EM-T-MOBILE-064-170329

Notice of Compliance with Conditions and Construction Completion

Subject: Modification Inspection Report

Site Data: **92 Weston St, Hartford CT, Hartford County**
Latitude 41° 47' 12.3", Longitude -72° 39' 44.42"
110 Foot – Monopole Tower

S-2A
FORGBOlT™
DETAILS

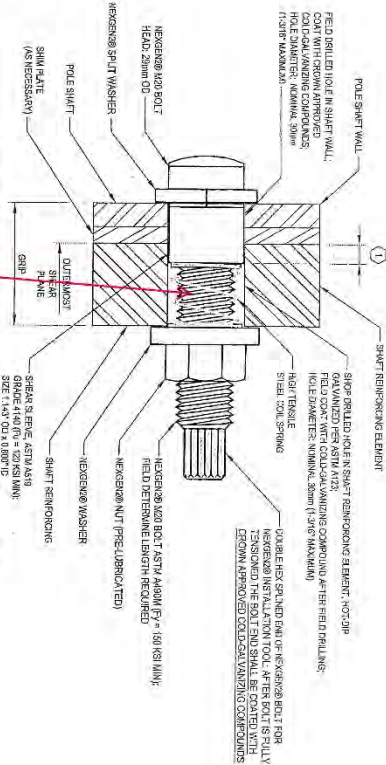
| Nonconformance # 2 | <table border="1"> <tr><th>MI Vendor</th></tr> <tr><td>Nonconformance</td></tr> <tr><td>Issue Description</td></tr> <tr><td>20 mm ForgBolts installed on flange bypass were varying lengths of 3-3/4" and 6" (measured from the flat plate to the edge of the bolt. Color coded grip lengths could not be verified as the color code is scraped off.</td></tr> <tr> <th>Section/Height/Elev</th> <th>Panel</th> <th>Leg</th> <th>Face/Flat</th> </tr> <tr> <td></td> <td></td> <td></td> <td></td> </tr> </table> | | | | MI Vendor | Nonconformance | Issue Description | 20 mm ForgBolts installed on flange bypass were varying lengths of 3-3/4" and 6" (measured from the flat plate to the edge of the bolt. Color coded grip lengths could not be verified as the color code is scraped off. | Section/Height/Elev | Panel | Leg | Face/Flat | | | | | <table border="1"> <tr><th>Crown</th></tr> <tr><td>GC Correction Required</td></tr> <tr><td>EOR</td></tr> <tr><td>Rejected</td></tr> <tr><td>Capacity Impact As Is</td></tr> <tr><td>N/A</td></tr> <tr><td>EOR Feedback By</td></tr> <tr><td>Ryan Ferrante</td></tr> </table> | Crown | GC Correction Required | EOR | Rejected | Capacity Impact As Is | N/A | EOR Feedback By | Ryan Ferrante | <table border="1"> <tr><th>Final Crown Approval</th></tr> <tr><td>Crown Approval By</td></tr> <tr><td>Enter Name of Crown Approver</td></tr> <tr><th>MI Vendor</th></tr> <tr><td>Status of Correction</td></tr> <tr><td>Conformance</td></tr> <tr><td>Type of Verification</td></tr> <tr><td>Non-Onsite Verification</td></tr> <tr><td>* Must be Crown Approved</td></tr> </table> | Final Crown Approval | Crown Approval By | Enter Name of Crown Approver | MI Vendor | Status of Correction | Conformance | Type of Verification | Non-Onsite Verification | * Must be Crown Approved |
|--|---|-----|-----------|--------------|----------------|----------------|--|--|---|-------|-----|-----------|--|--|--|--|---|-------|------------------------|-----|----------|-----------------------|-----|-----------------|---------------|--|----------------------|-------------------|------------------------------|-----------|----------------------|-------------|----------------------|-------------------------|--------------------------|
| EOR Comments: | There is only one size ForgBolt that has the required grip length for this application. As such I would expect all bolts to have the same projection from the modification plate. It appears that the incorrect length of bolt was used in some locations. This may be related to the gap reported in item #3. | | | | | | | | | | | | | | | | | | | | | | | | | | | | | | | | | | |

| Nonconformance # 2 | <table border="1"> <tr><th>MI Vendor</th></tr> <tr><td>Nonconformance</td></tr> <tr><td>Issue Description</td></tr> <tr><td>20 mm ForgBolts installed on flange bypass were varying lengths of 3-3/4" and 6" (measured from the flat plate to the edge of the bolt. Color coded grip lengths could not be verified as the color code is scraped off.</td></tr> <tr> <th>Section/Height/Elev</th> <th>Panel</th> <th>Leg</th> <th>Face/Flat</th> </tr> <tr> <td></td> <td></td> <td></td> <td></td> </tr> </table> | | | | MI Vendor | Nonconformance | Issue Description | 20 mm ForgBolts installed on flange bypass were varying lengths of 3-3/4" and 6" (measured from the flat plate to the edge of the bolt. Color coded grip lengths could not be verified as the color code is scraped off. | Section/Height/Elev | Panel | Leg | Face/Flat | | | | | <table border="1"> <tr><th>Crown</th></tr> <tr><td>GC Correction Required</td></tr> <tr><td>EOR</td></tr> <tr><td>Rejected</td></tr> <tr><td>Capacity Impact As Is</td></tr> <tr><td>N/A</td></tr> <tr><td>EOR Feedback By</td></tr> <tr><td>Ryan Ferrante</td></tr> </table> | Crown | GC Correction Required | EOR | Rejected | Capacity Impact As Is | N/A | EOR Feedback By | Ryan Ferrante | <table border="1"> <tr><th>Final Crown Approval</th></tr> <tr><td>Crown Approval By</td></tr> <tr><td>Enter Name of Crown Approver</td></tr> <tr><th>MI Vendor</th></tr> <tr><td>Status of Correction</td></tr> <tr><td>Conformance</td></tr> <tr><td>Type of Verification</td></tr> <tr><td>Non-Onsite Verification</td></tr> <tr><td>* Must be Crown Approved</td></tr> </table> | Final Crown Approval | Crown Approval By | Enter Name of Crown Approver | MI Vendor | Status of Correction | Conformance | Type of Verification | Non-Onsite Verification | * Must be Crown Approved |
|--|---|-----|-----------|--------------|----------------|----------------|--|--|---|-------|-----|-----------|--|--|--|--|---|-------|------------------------|-----|----------|-----------------------|-----|-----------------|---------------|--|----------------------|-------------------|------------------------------|-----------|----------------------|-------------|----------------------|-------------------------|--------------------------|
| Crown Comments: | Skyclimber to provide material docs for bolts used. | | | | | | | | | | | | | | | | | | | | | | | | | | | | | | | | | | |

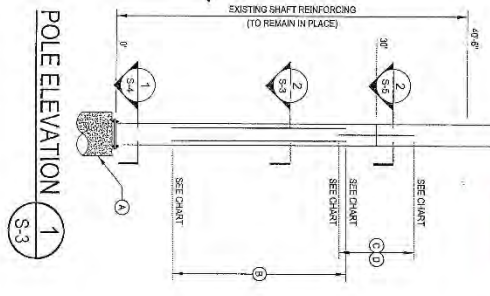
Modification Jump plates at 30" measure PL 6-1/4"x1" instead of PL 6"x1", EOR Approved

MONOPOLE PROFILE
S-3

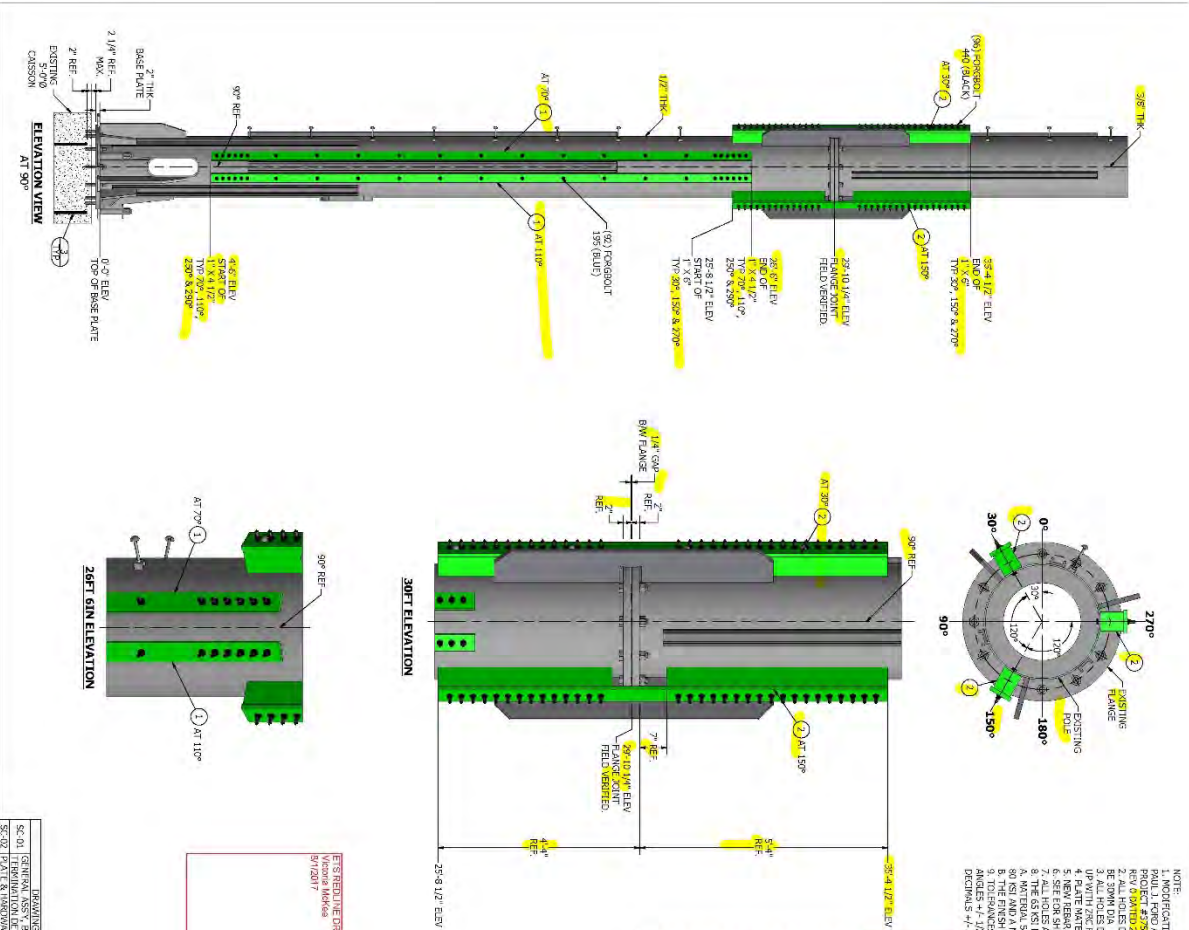
The step pegs on the right side 290" modification plate are not centered with the left side pegs on the flange jump at 30". The step pegs on the right are approximately 6" above the desired center location. EOR Approved
